# HIPRO ELECTRONICS(Dongguan) COMPANY LIMITED

NO.:D200404013

<b>TITLE:(BURN-IN) 加熱縮時計劃</b>	<b>PAGE: 2</b>	<b>DOC NO: I-ENG-109</b>

2 B/I time reduction plan : 加熱時間縮時計劃

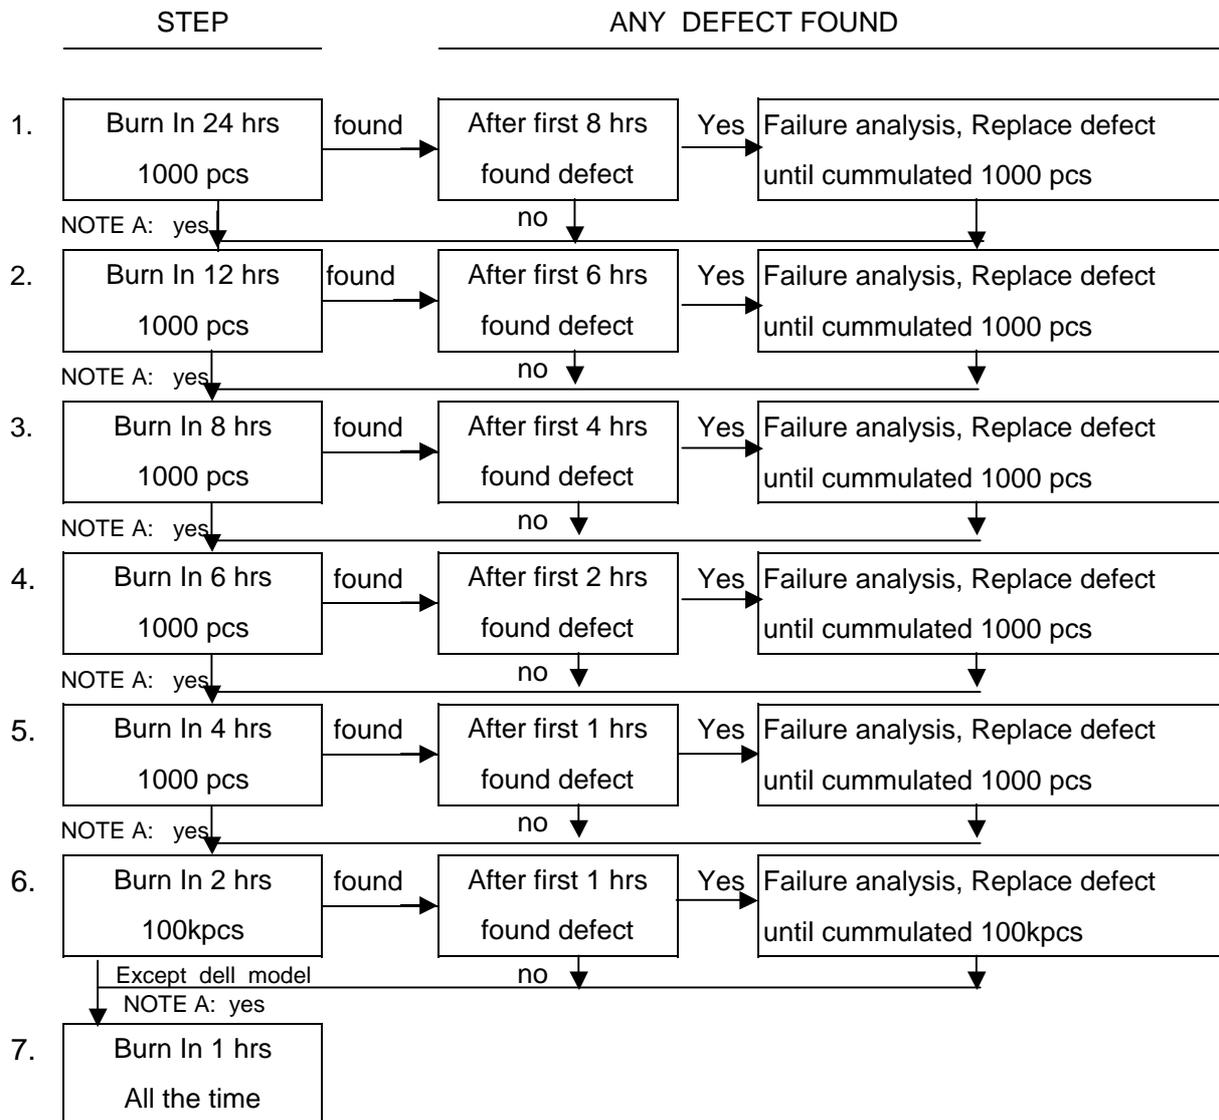
1.6 Non-dell model next 100k units burn-in shall be done for 2 hours, long term burn-in 2 hours for dell model.

1.6.1 Once the defect found after 1 hour, the burn-in quantity shall be re-calculated from next lot until no defect found after 1 hour, then go next step. The defect shall be failure analysis and propose CAR.

1.6.2 When no defect found after 1 hour, submit PCR with burn-in data for customer or ENG manager approval, yes, go next step.

1.7 Non-dell model long term burn-in shall be done for 1 hours.

STEPS 步驟 : NOTE A: no defect (submit PCR with burn-in data for Customer approval)
